Access Compliance Report Public Rights-of-Way (Pedestrian Signals)

Main Street: **E_SPRING_ST** Cross Street: **HEWES_ST** Location: **SE**

ADA ID: **SGAT210928125703** Signal Type: **One Push Button-Non APS** Overall Compliance: **No** Severity Scores: **BTN 1: 35** **BTN 2: N/A** **No BTN: N/A**

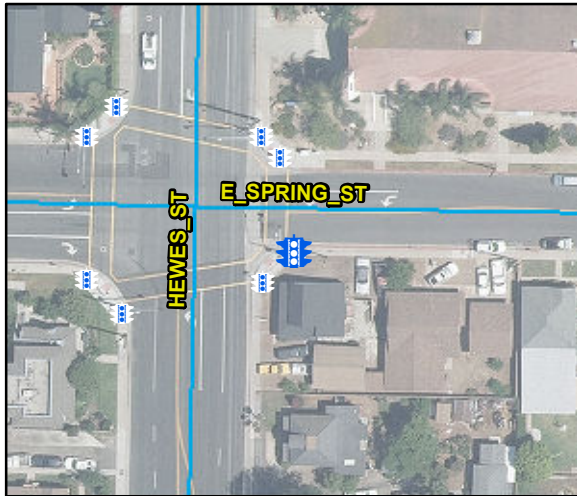
OC Std/PROW: **R404.2, MUTCD 4e.08**

Possible Solutions: Replace Signal Push Button With APS Button. Remove and Replace Clear Space.
